NSD-NRC-97-5113
DCP/NRC0853
Docket No.: STN-52-003

SUBJECT: AP600 RESPONSE TO REQUESTS FOR ADDITIONAL INFORMATION

**Enclosure to Westinghouse
Letter NSD-NRC-97-5113**

Question: 720.371 (OITS #5119)

Figure 720.371-1

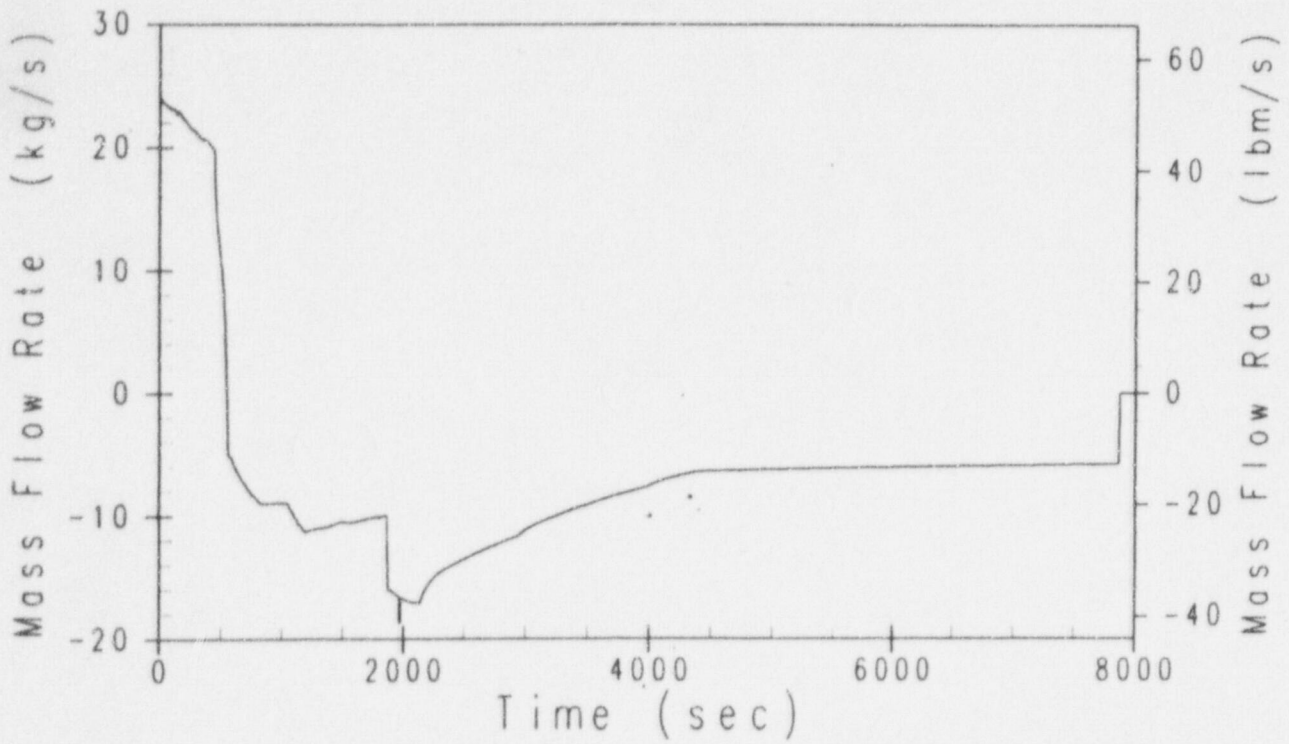
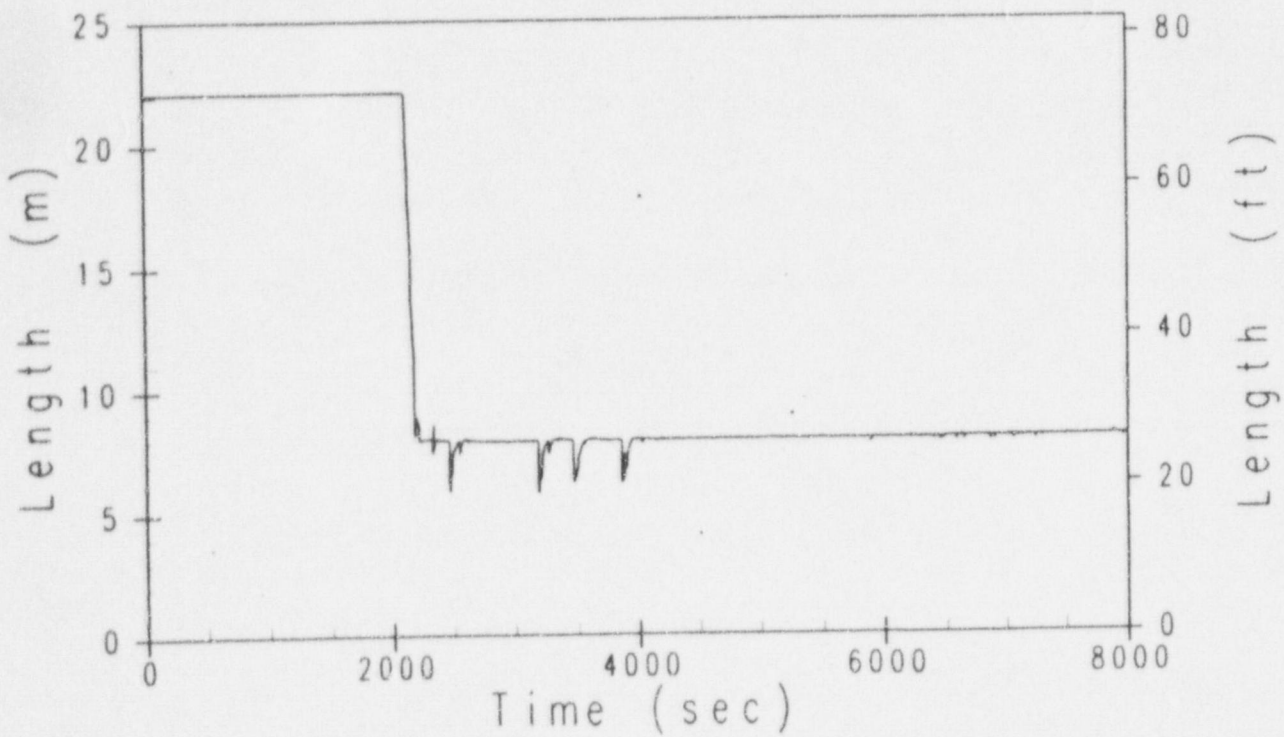
- a. Are there any T-H analyses to support this sequence? Can the leak be stopped before uncovering the core or passing water through the secondary side safety valves?

There are T-H analyses to support this sequence and were discussed at the meeting of January 22, 1997. These analyses show that there is more time for the operators to act than is assumed in the PRA analysis, and the leak from the primary side to the secondary side is stopped before uncovering the core. The analyses also show, as was discussed on January 22, 1997, that the safety valves are not challenged. With the reactor coolant pumps (RCPs) running, the passive residual heat exchanger (PRHR HX) removes the decay heat exceptionally well (forced convection through the heat exchanger). The removal of heat from the RCS depressurizes the primary side and stops the leak flow through the broken tube in less than 10 minutes. This is shown in Figure 720.371-1. Although a computer simulation is not essential to understand this principle of thermal-hydraulic analysis, the figure (and the other figures that follow) is from a computer run done specifically to satisfy this question. At no time in this transient does the core uncover. This is shown in Figure 720.371-2. That figure shows the RCS temperature compared to the saturation temperature (T_{sat}). Note that the RCS temperature drops rapidly and does not increase. Figure 720.371-3 shows the heat removal from the RCS through the PRHR HX and the heat input to the RCS, the decay heat. The heat removal from the RCS is significantly larger than the decay heat during and after the transient. The RCS level is shown in Figure 720.371-4. This figure shows the level remains above the core until the ADS opens. The level then drops to the hot leg level (where the ADS valves are). This is above the level of the core.

As shown in Figures 720.371-1 and 720.371-4 the operators do not need to open the ADS stage 1 valves to depressurize the RCS. The leak flow is stopped by the heat removal through the PRHR HX and the PRHR also depressurizes the RCS. The PRA model conservatively assumes that the RCS must be depressurized to the containment atmosphere pressure to terminate the transient. The PRA also assumes that the depressurization through the ADS further requires the injection of the IRWST water and the success of the recirculation function. The analysis shows the PRA is a very conservative model, because the depressurization through the ADS is not needed. Thus, the operators have longer than is modeled in the PRA to act to open the ADS stage 1 valves. The preferred means of doing something is to follow the Emergency Response Guidelines (ERGs) as was discussed in the response to RAI 720.326. Those guidelines will direct the operators to depressurize the RCS, and use the ADS if that is what is needed.

Figure 1 - AP600 SG Tube Rupture Levels of Defense

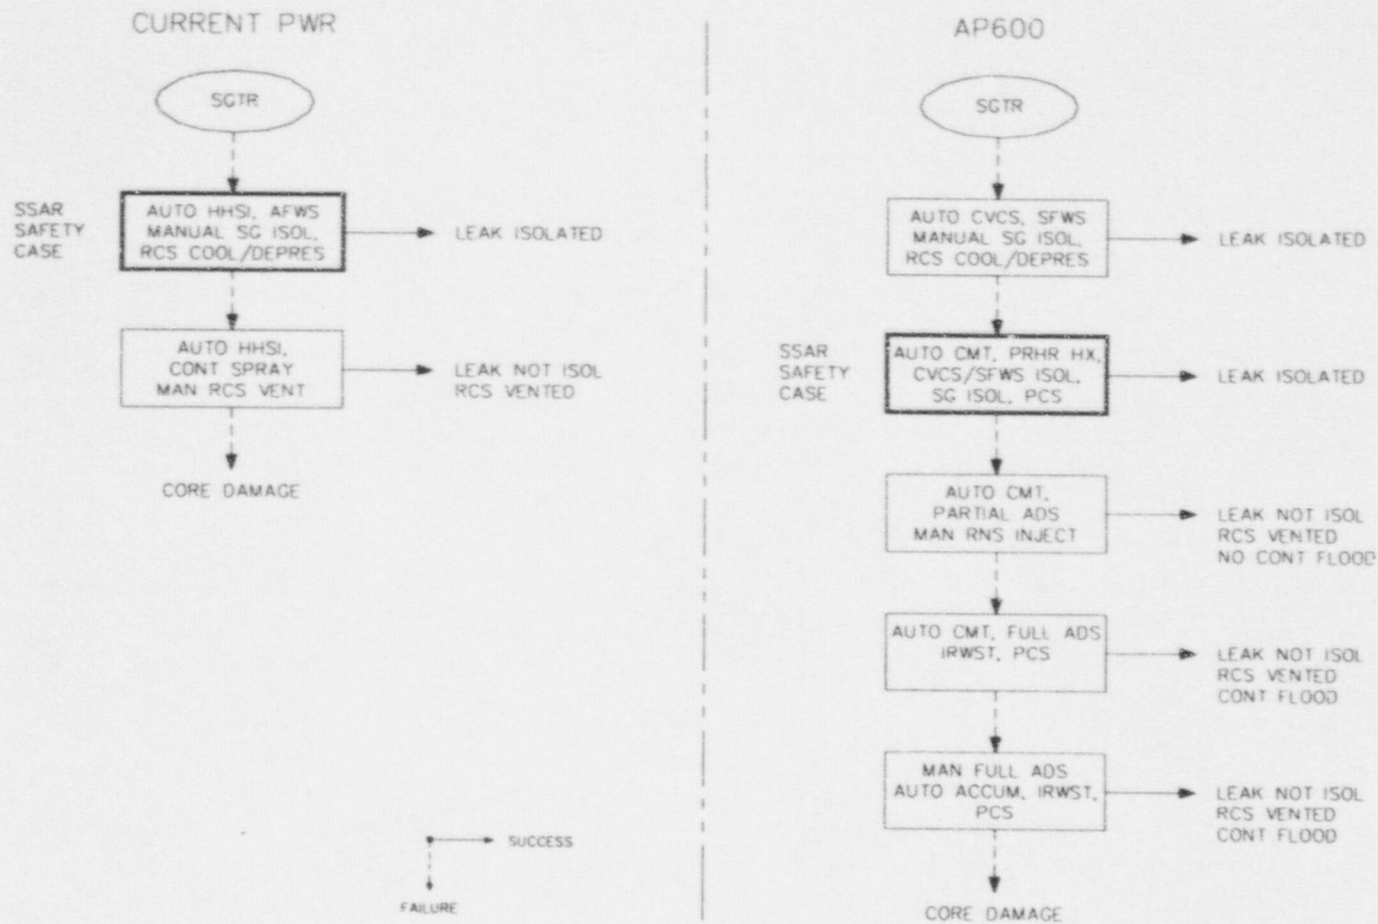
Action Item: 1. The staff asked Westinghouse to perform thermal-hydraulic analyses as necessary to support the success criteria assumed in the SGTR event tree. [A specific staff concern is ...] Lack of thermal-hydraulic analyses supporting the assumption that the AP600 design can rely on non-safety related systems only as a first line of defense to mitigate SGTR accidents (sequence 1 SGR-OK1 in event tree, see page 4-128 of PRA).

The AP600 provides three different responses to a SGTR. One response uses active features and operator actions that are similar to current plants. This is the only success path without safety systems in the PRA models. It is shown in Chapter 4 of the PRA. The other two responses use passive features that are automatic and independent of AC power. These three responses provide significantly greater redundancy and diversity than is provided by current plants which results in significant risk improvements. Figure 1 illustrates these different responses including several possible variations of the AP600 ADS based response.
